# Memo

Re: DeKalb 503 - Bridge Rehabilitation Project – Addendum No. 1

**ITEMIZED PROPOSAL**  
**Bridge Rehabilitation**  
**DeKalb County Bridge No. 503 - Auburn Driver over Cedar Creek**  
**June 8, 2026**

<p>City of</p>  <p>"Home of the Classics"</p>	<b>AUBURN STREET DEPT.</b>	
	TYPICAL STREET DETAIL	NOT TO SCALE
	TYPICAL ASPHALT PAVEMENT	DATE: JULY 18, 2023
		DRAWING ST12

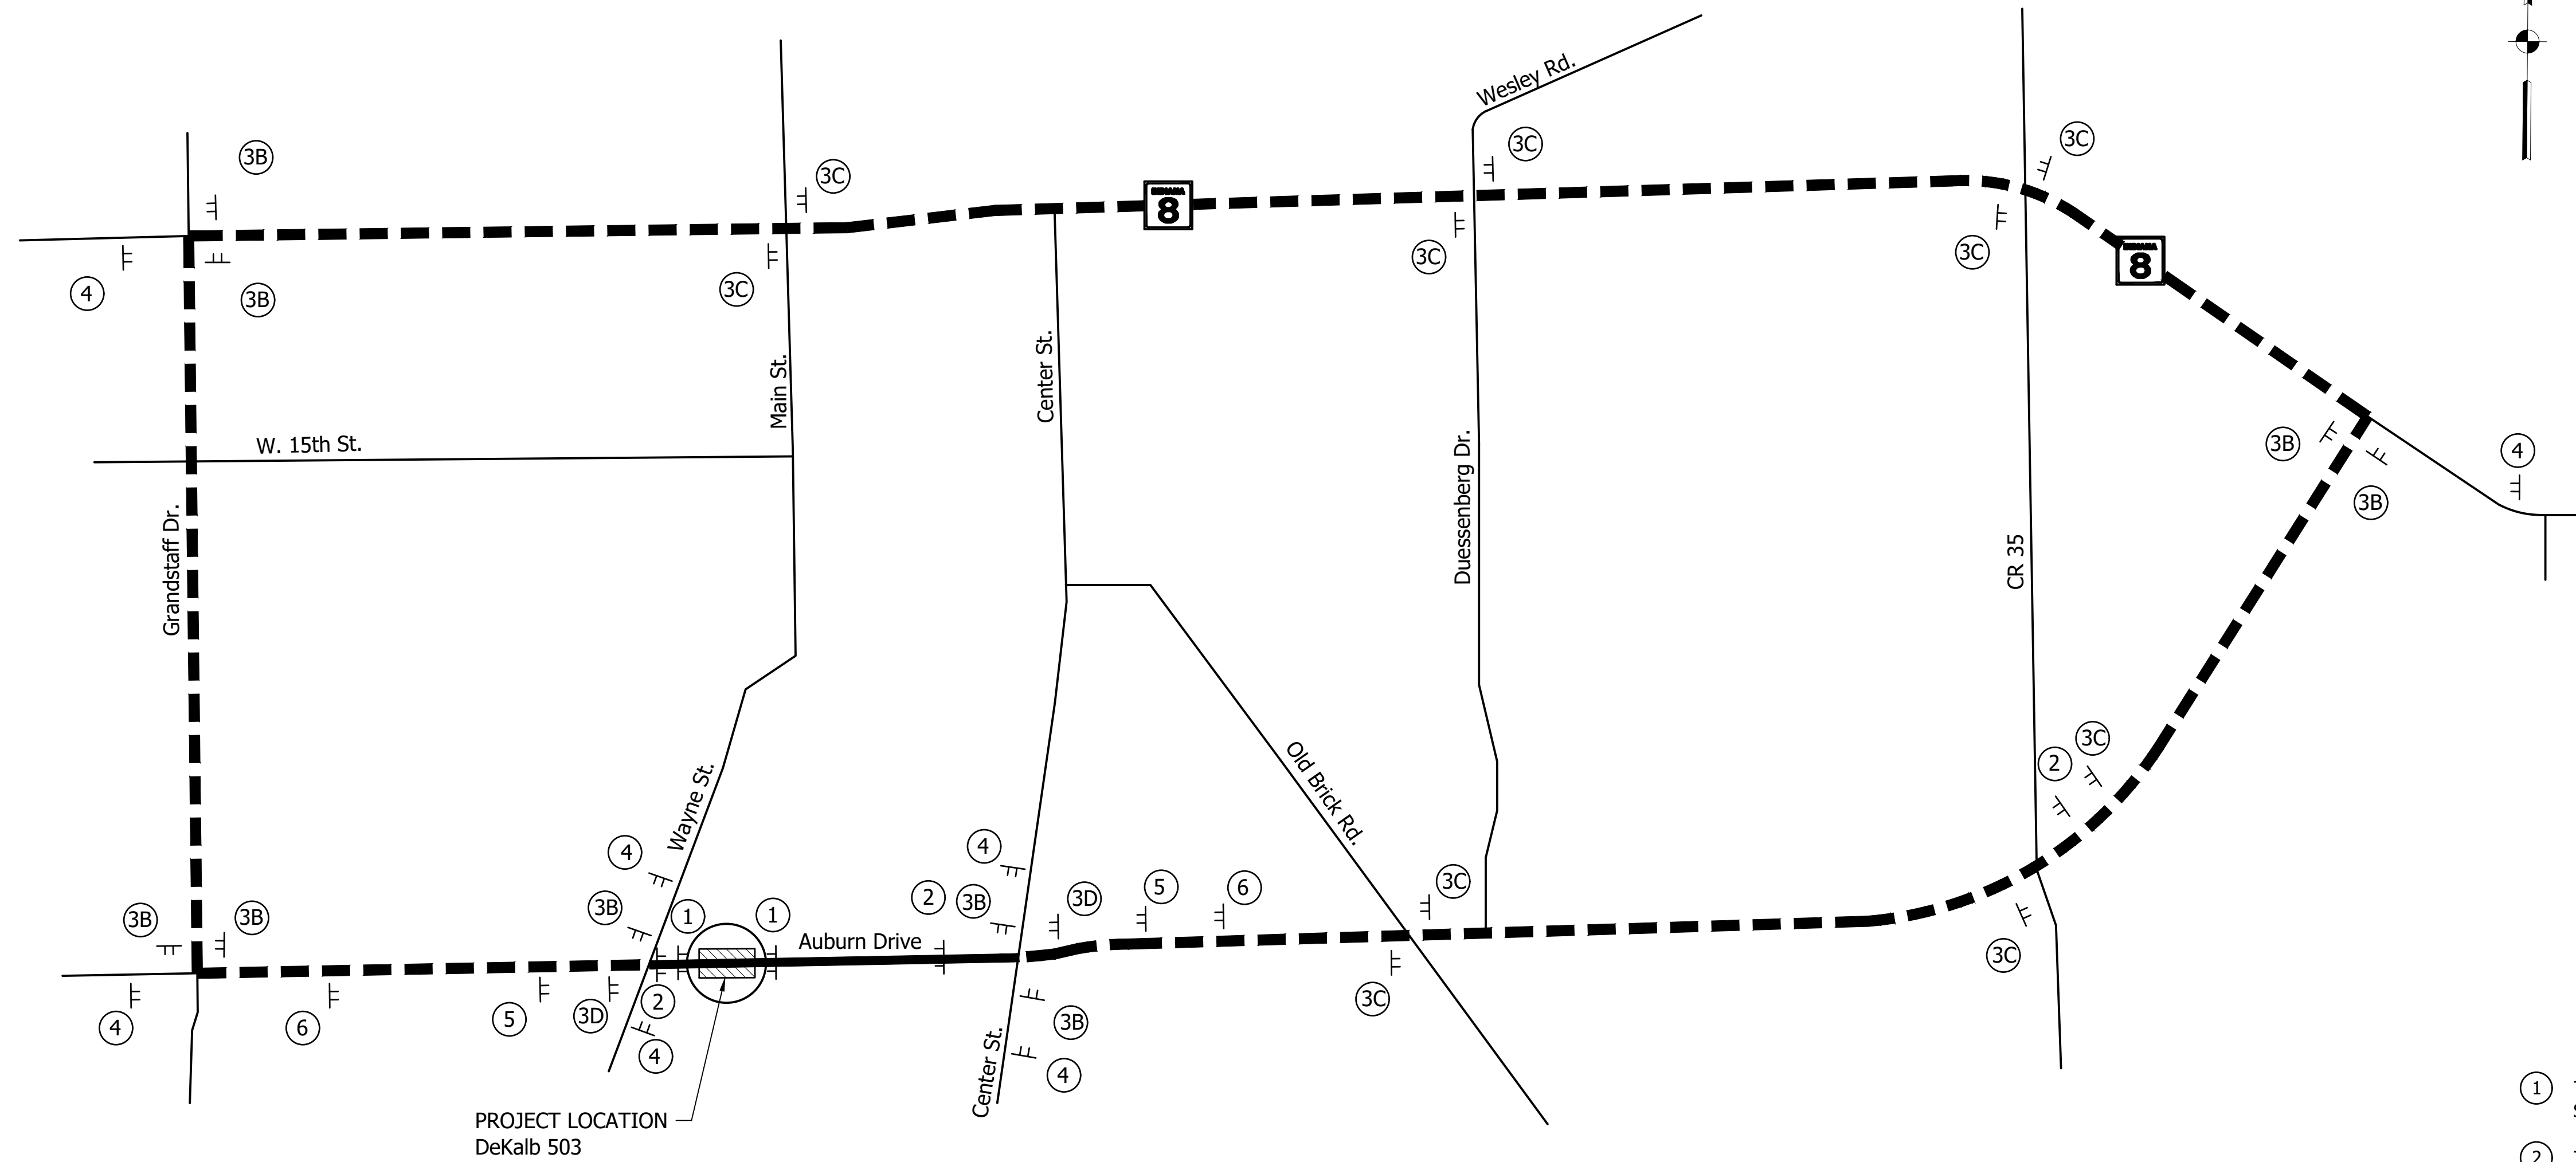
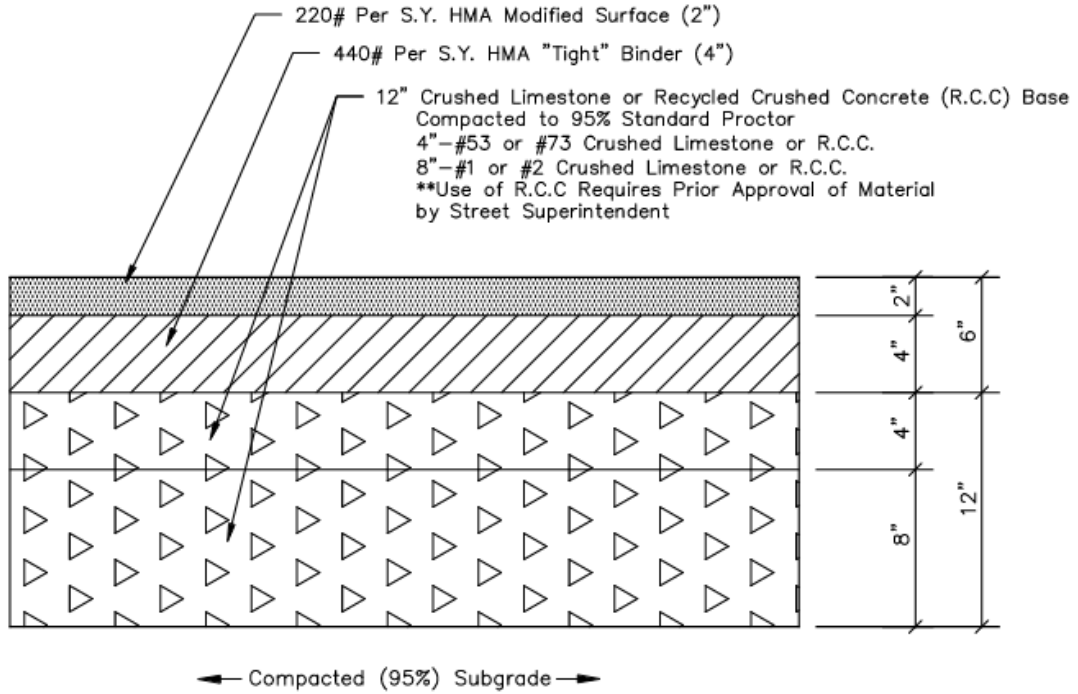
SP19. MODIFIED ASPHALT SURFACE

The modified asphalt surface material shall conform to the City of Auburn's Typical Asphalt Pavement section shown in the exhibit on the following page.

Q: Can you clarify the "modified" asphalt surface?

1. HMA "Modified" Surface Asphalt shall consist of the following materials:
  - 25% of #11 Limestone; 30% of #12 Limestone; 45% Sand; with 6% Liquid Asphalt.
2. No metal slag shall be used in either mix for binder or surface asphalt. A maximum of twenty percent (20%) of recycled asphalt pavement (RAP) may be used in binder mix. A maximum of five percent (5%) of recycled asphalt pavement (RAP) may be used in surface mix. The 5% RAP content for surface mix can be used as part of the overall mix percentage for #11 Limestone or #12 Limestone. Contractor shall submit shop drawing breakdown of both asphalt mixes. All delivery tickets for HMA binder and surface shall clearly state the contents and percentages, including RAP, of the asphalt mix. Compaction shall be per Section 402.15 of the current INDOT Standard Specifications.

**A: Special Provision No. 19 was added to provide information for the modified asphalt surface. This is included in Addendum No. 1.**

**DETOUR - PLAN**  
No Scale

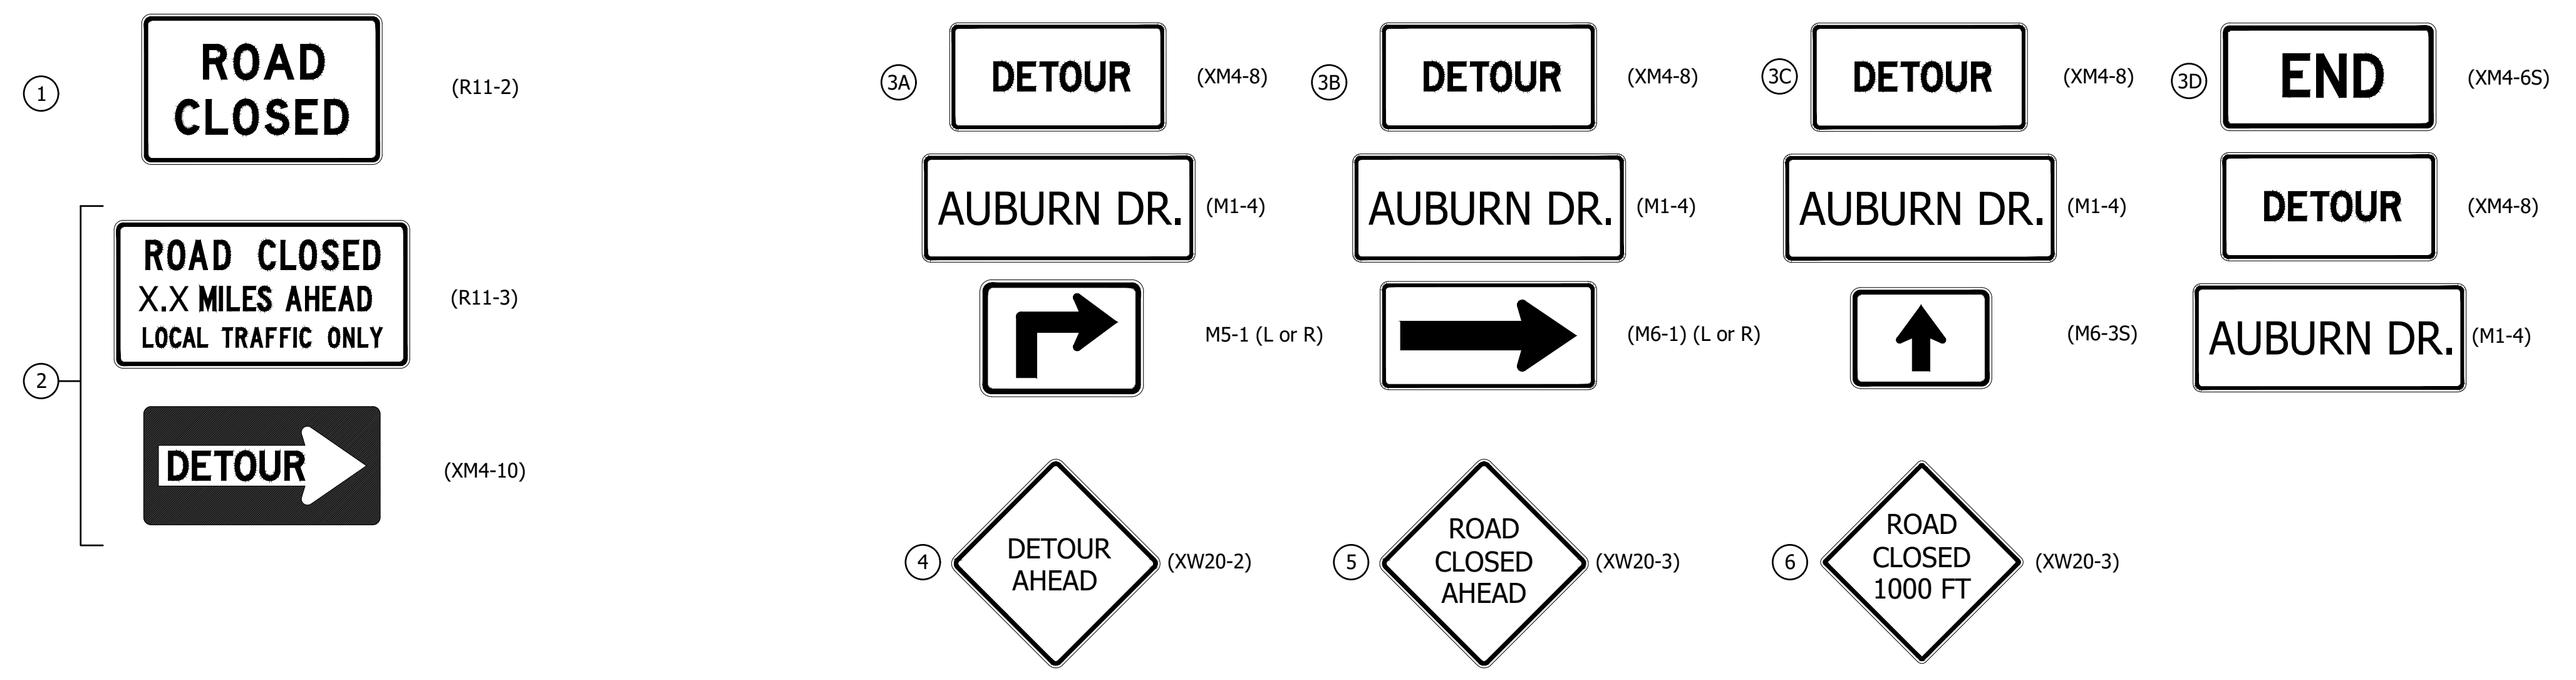
Sheet Deleted	Sheet Added	Description of Change
2	2-A	Updated Revision Index
4	4-A	Revised Construction Sign Summary

Q: Should Pay Item #55; Construction Sign, Type B be Construction Sign Type A?

CONSTRUCTION SIGN SUMMARY	
TYPE	QUANTITY
Construction Sign, A	11 Ea.
Barricade, III-A	48 Lft.
Barricade, III-B	72 Lft.
Road Closure Sign Assembly	5 Ea.
Detour Route Marker Assembly	21 Ea.

**A: Concur. The Itemized Proposal (Page 12 of the CIB) and the Detour Sheet (Page 4 of the plans) have been revised to reflect this change. This is included in Addendum No. 1.**
